**TITLE: 2021 Z400 ABS, NINJA® 400 & NINJA® 400 ABS
CAMSHAFT CHAIN TENSIONER REPLACEMENT**

RECALL

IMPORTANT SAFETY RECALL NHTSA RECALL NO. 20V-774

Kit, Camshaft Chain Tensioner, MC20-13 P/N 99999-0795		
Ref	Contents	Qty
1	Tensioner Body	1
2	O-Ring	1

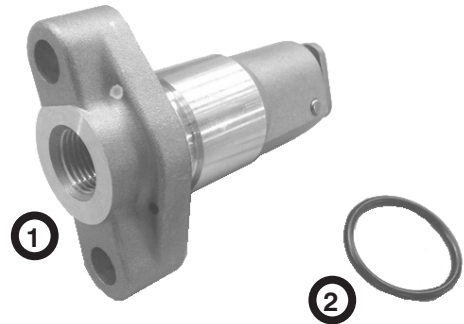
Kawasaki has initiated a Recall campaign to repair all eligible units. The repair consists of replacing the camshaft chain tensioner.

Camshaft Chain Tensioner Installation

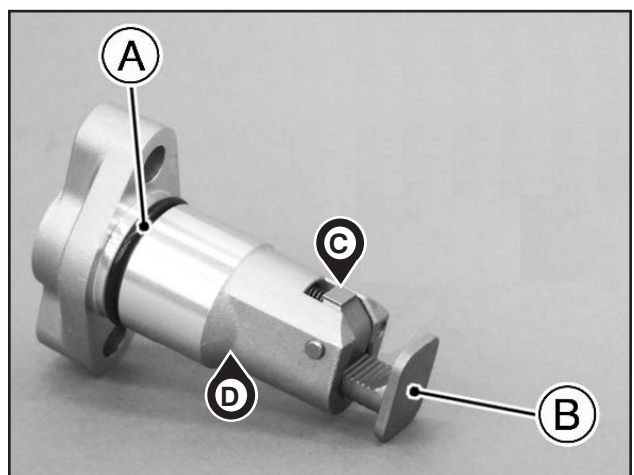
- Install the new O-ring [A] from the repair kit on the new camshaft chain tensioner [B] from the repair kit.
- Apply grease to the O-ring.
- Release the stopper [C] and push the push rod [D] fully into the tensioner body [B].

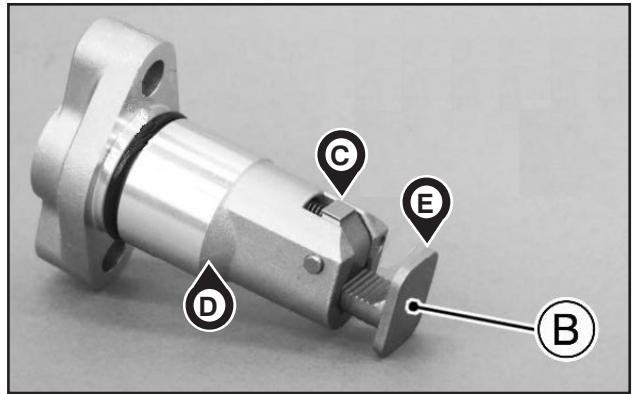
- Install the tensioner body [D] so that the longer edge [E] of the push rod [B] and the stopper [C] faces upward.

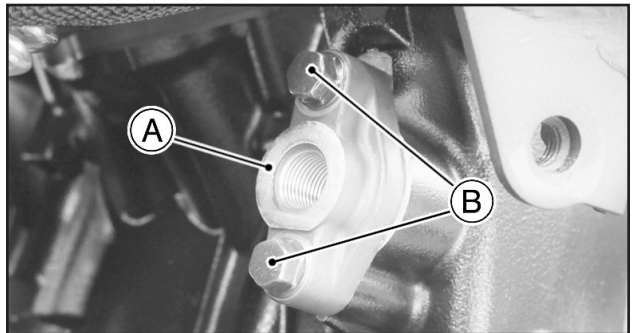
- Tighten the camshaft chain tensioner [A] mounting bolts [B] to 87 in·lb (1.0 kgf·m, 9.8 N·m).

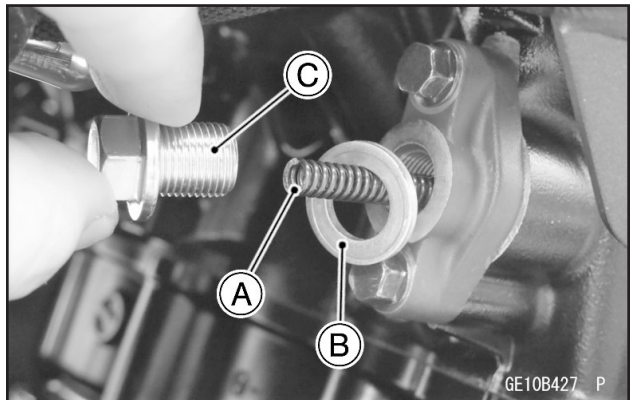
- Install spring [A], washer [B] and cap bolt [C].
- Tighten the camshaft chain tensioner cap bolt [C] to 15 ft·lb (2.0 kgf·m, 20 N·m).

Repair Verification

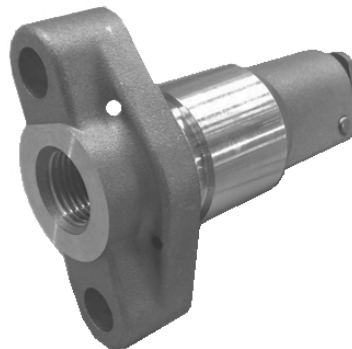
- The white paint mark on the new camshaft chain tensioner as shown below will serve as repair verification.
